DR-ALT-33

Table DR-ALT-37-1 Palen Solar Power Project: Environmental Comparison of Alternative Sites

Ideal HelioTrough Loop Geometry and Layout

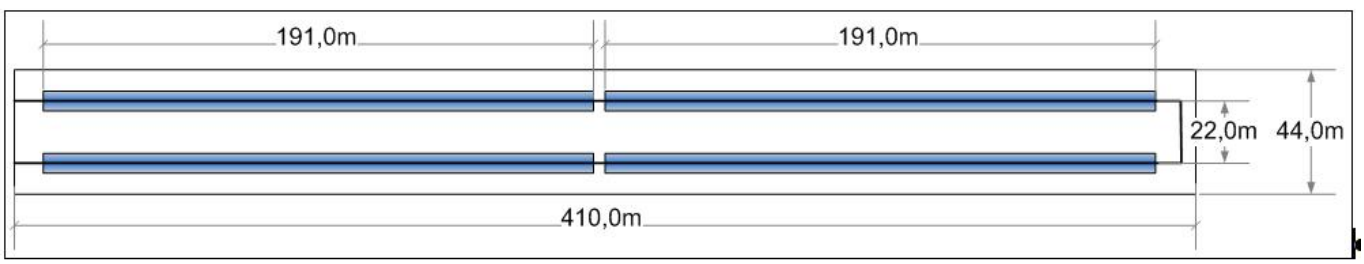
Please describe in detail the engineering constraints, if any, to the development of a revised configuration of each 250 MW unit. A revised configuration may result in the rows of troughs not being as long and not configured in a solid rectangular area. As an example, it may be desirable to allow existing washes to pass through an undeveloped portion of the site and to allow troughs to be installed on either side of the wash.

a. Please define whether there is a specific minimum or maximum length that each individual solar collector loop assembly must be, and if it is necessary that the solar collector loops be identical in length. Please define both engineering and economic constraints to having variable collector loop lengths.

The basic building block of a parabolic trough solar field is the so-called "loop". Each loop is made up of 40 solar collector assemblies with an aperture area of 5,025 square meters. A loop is carefully engineered with the specified collector area and a range of flow rates to raise the temperature of the heat transfer fluid (HTF) circulating in the solar field from the "cold " temperature that exists at the first preheater in the steam generation train to the maximum, design point temperature of the system. In the case of the proposed Project (and all other solar trough plants that use Therminol® VP1 or equivalent synthetic oil as the heat transfer fluid,[1]) the cold return HTF temperature is approximately 300 degrees Celsius (°C) and the hot design point temperature is approximately 400°C.

Each Heliotrough loop is made up of 4 collectors 191 meters in length with an aperture width of 6.77 meters. To ensure optimal annual energy capture, it is critical that loops be oriented in a precise north-south alignment. The "U" shaped loop illustrated below is optimal from a pressure drop standpoint. This allows the hot and cold headers to be routed in the same header pipe corridors, with the delivery and return points of the HTF at roughly the same location. While it is possible to double each collector section back on itself, in a "W" shape, this results in large additional pressure drop in each loop. Furthermore, an optimal layout will have opposing loops on the north and south side of an east-west header. An optimal solar field will therefore be laid out in 820 meter (approximately ½ mile) north-south increments.

Figure DR-ALT-38-1
CNDDB Search Results for Alternative Site: Cibola

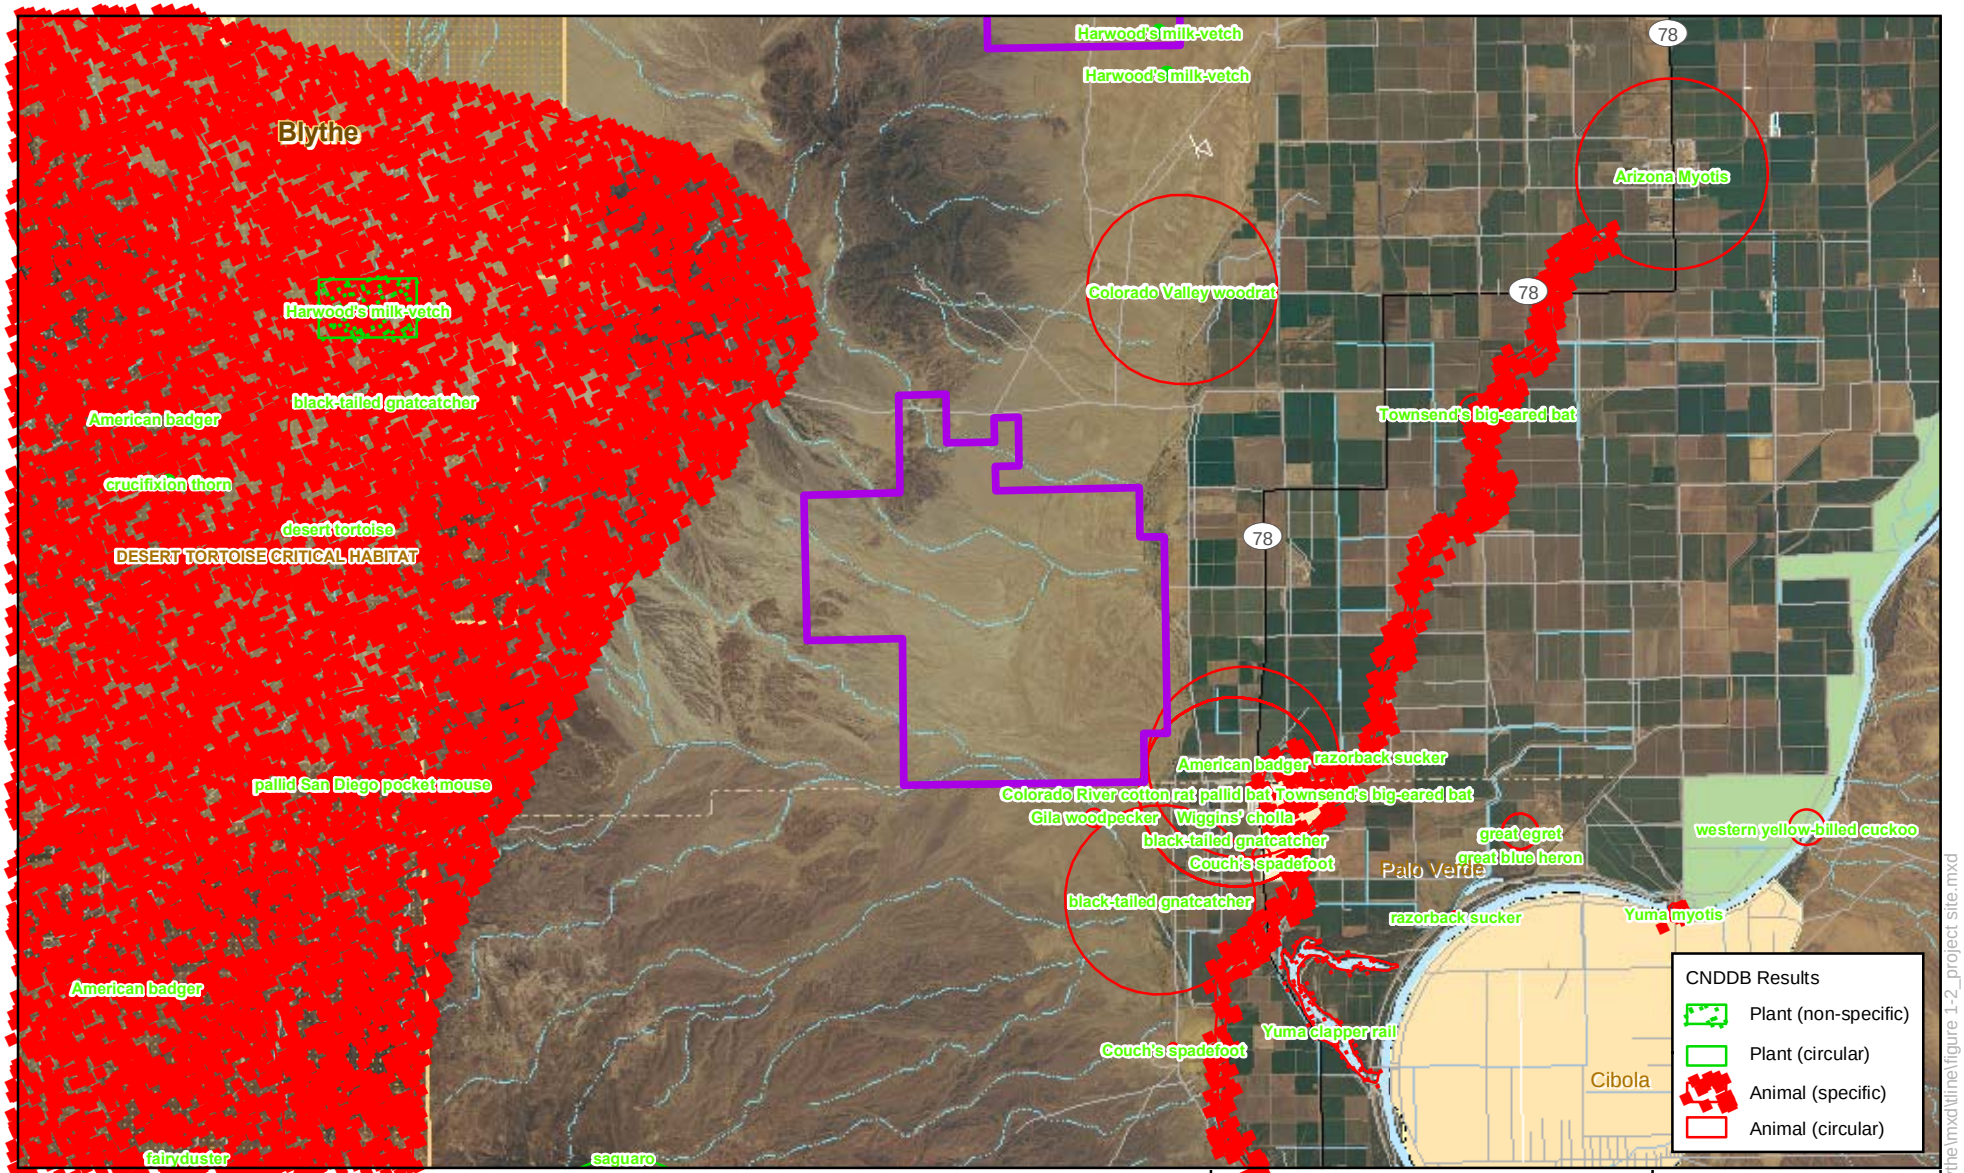
One of the site selection criteria for the proposed Palen SPP site was environmental sensitivity. Please provide the results of a CNDDB search for the Cibola alternative site.

Figure DR-ALT-38-1 shows the results of the CNDDB search for the Cibola alternative site. The data provided below are for the site itself plus a five-mile radius. Special-status species identified include the following:

Species	Status
Crucifixion thorn	CNPS 2.3
Fairyduster	CNPS 2.3
Harwood's milk-vetch	CNPS 2.2
Saguaro	CNPS 2.2
Wiggins' cholla	CNPS 3.3
Razorback sucker	Fed – Endangered; State – Endangered
Couch's spadefoot	State – Species of Special Concern
Gila woodpecker	State – Endangered
Western yellow-billed cuckoo	Fed – Candidate; State Endangered
Yuma clapper rail	Fed – Endangered; State – Threatened
Desert tortoise	Fed – Threatened; State – Threatened
American badger	State – Species of Special Concern
Arizona myotis	State – Species of Special Concern
Colorado River cotton rat	State – Species of Special Concern
Pallid Bat	State – Species of Special Concern
Pallid San Diego pocket mouse	State – Species of Special Concern
Townsend's big-eared bat	State – Species of Special Concern

Figure DR-ALT-40 -1
CNDDB Search Results for Alternative Site: North of Desert Center

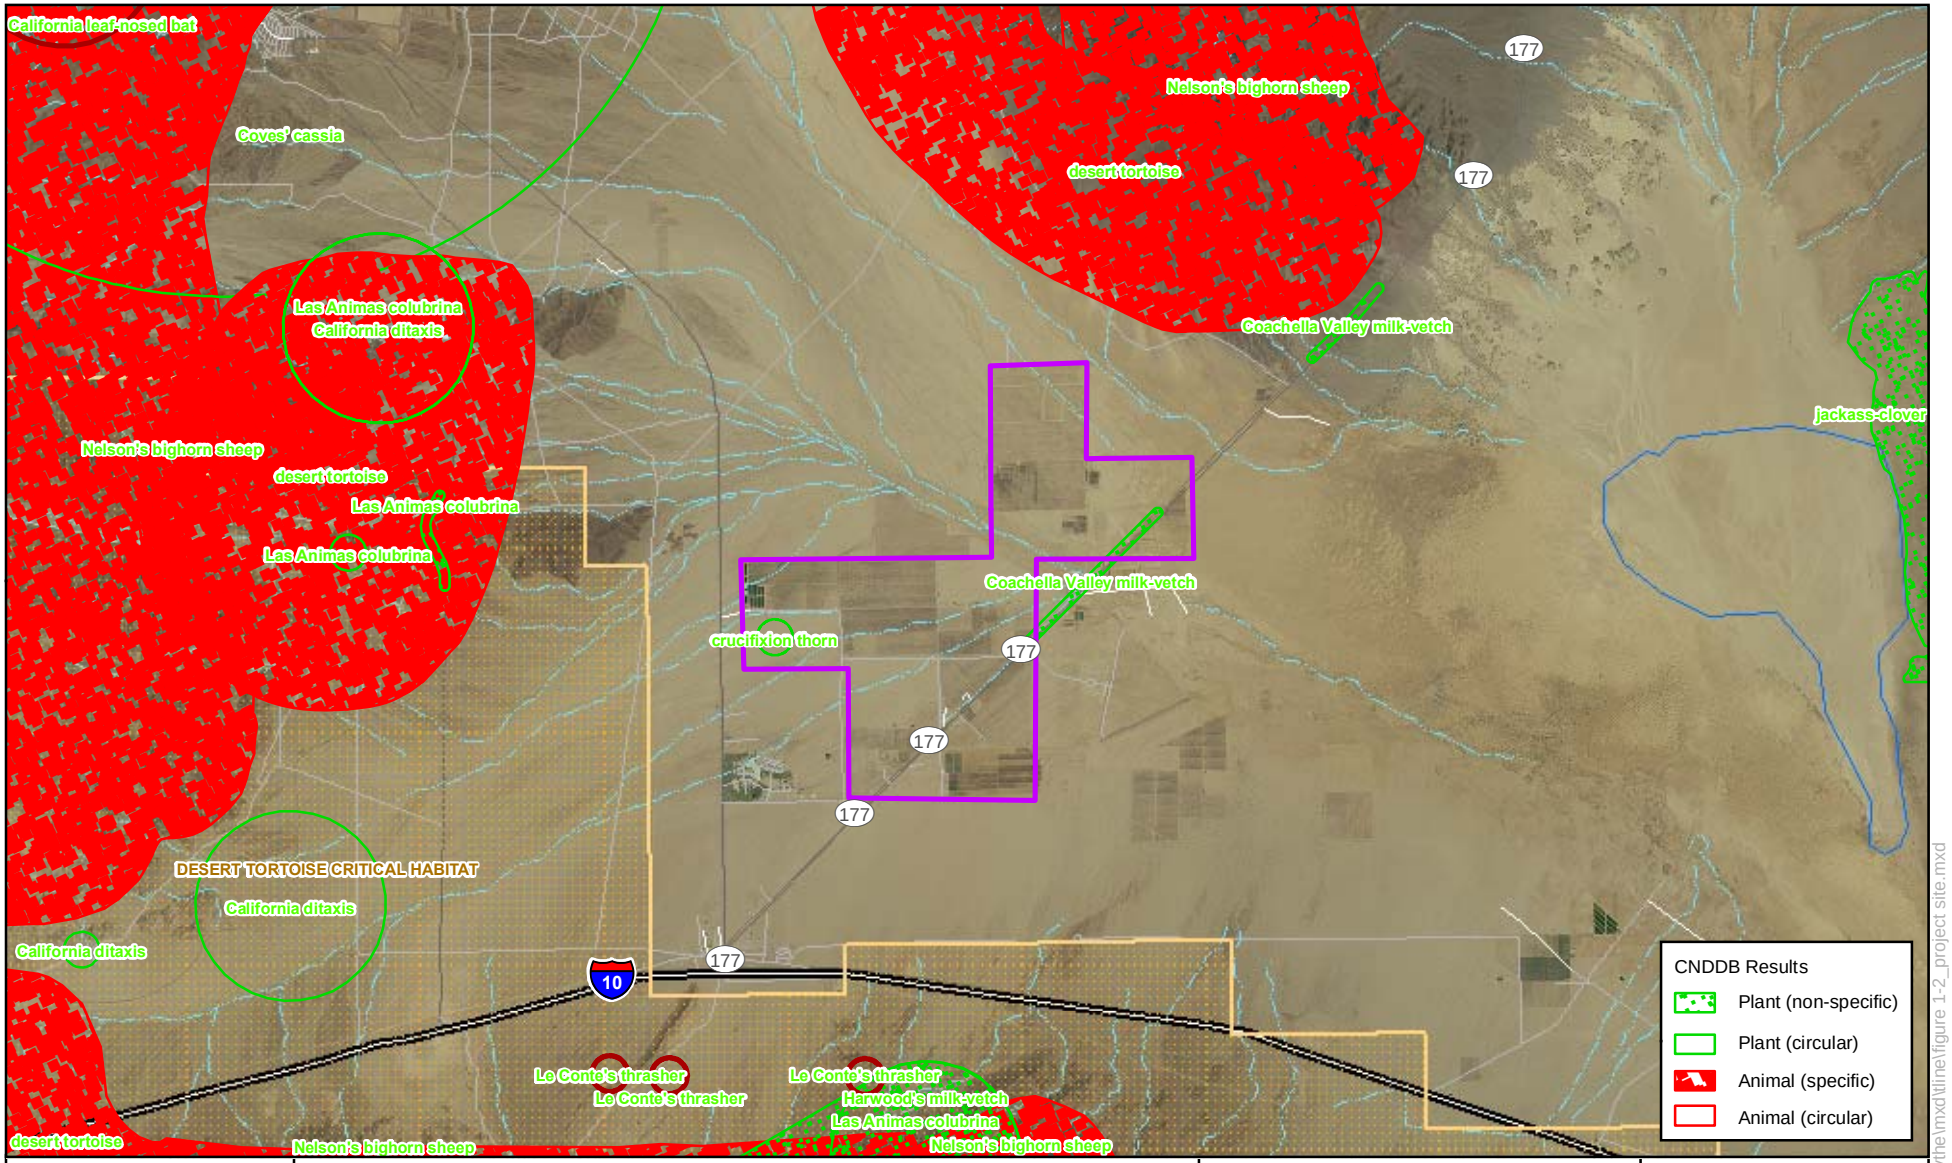
One of the site selection criteria for the proposed Palen SPP site was environmental sensitivity. Please provide the results of a CNDDB search for the North of Desert Center alternative site.

Figure DR-ALT-40-1 shows the results of a CNDDB search for the North of Desert Center Alternative site suggested for consideration by the California Energy Commission (CEC). The data provided below encompass the site itself plus a 5-mile radius. Special-status species identified include the following:

Species	**Status**
California ditaxis	CNPS 3.2
Coachella Valley milk-vetch	Fed – Endangered; CNPS 1B.2
Coves' cassia	CNPS 2.2
Crucifixion thorn	CNPS 2.3
Las Animas colubrina	CNPS 2.3
Harwood's milk-vetch	CNPS 2.2
Jackass-clover	CNPS 2.2
Le Conte's thrasher	State – Species of Special Concern
Desert tortoise	Fed – Threatened; State – Threatened

Figure DR-ALT-46-1
Earlier Project Configuration with Solar Fields Extending Further North

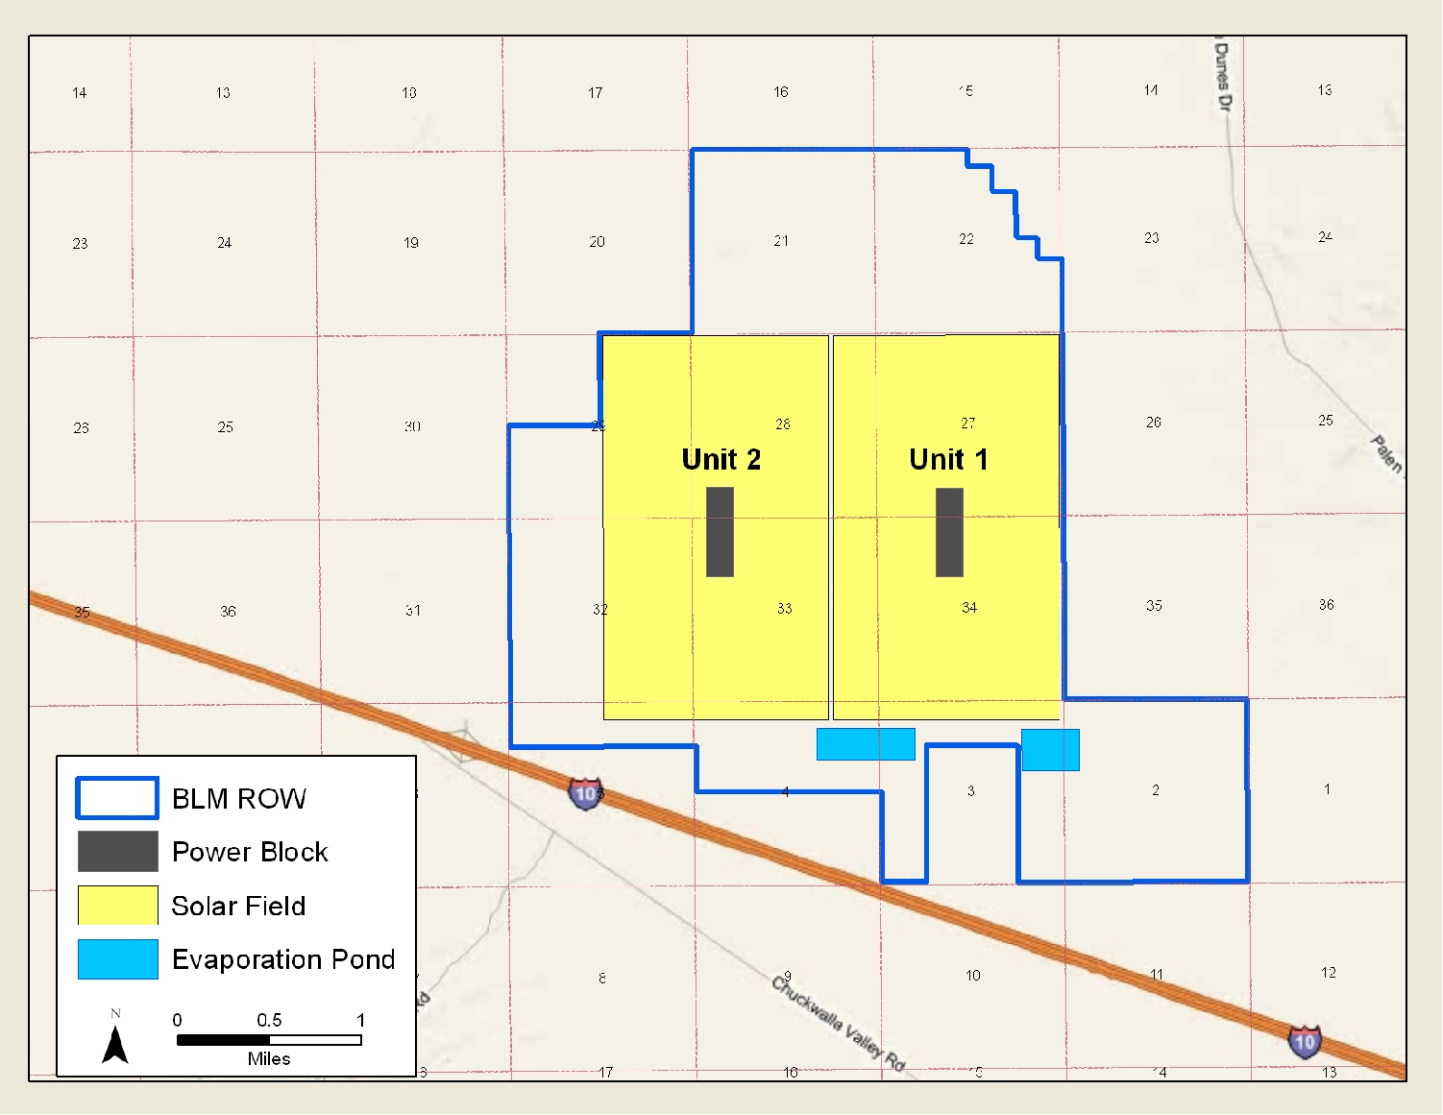
> Please provide detailed information regarding any alternative configurations/engineering considered but rejected by the applicant. Please include details regarding the engineering constraints to each alternative configuration.

An earlier configuration of the Project, the solar fields were longer on the north south axis and narrower in width (see Figure DR-ALT-46-1). The Applicant changed the configuration to move the solar fields further away from the ancient lake shore, sand dunes and playa in the northern portions of the ROW, by widening and shortening the solar fields (see Figure DR-ALT-46-2). In addition, in June 2009, the Applicant decreased the ROW size for PSPP by relinquishing almost two full sections in the northern portion of the ROW. This area, which is closer to Palen Dry Lake, was relinquished for environmental stewardship reasons to minimize the Project’s impact on biological and cultural resources (see Figure DR-ALT-46-3). With regard to engineering constraints, the solar fields have minimum size requirements to generate adequate energy, the drainage channels have minimum size requirements to convey any surface water and the internal roads and fencing have clearance requirements. Within the existing ROW, each one of these factors pushes the Project components up the ROW boundary.
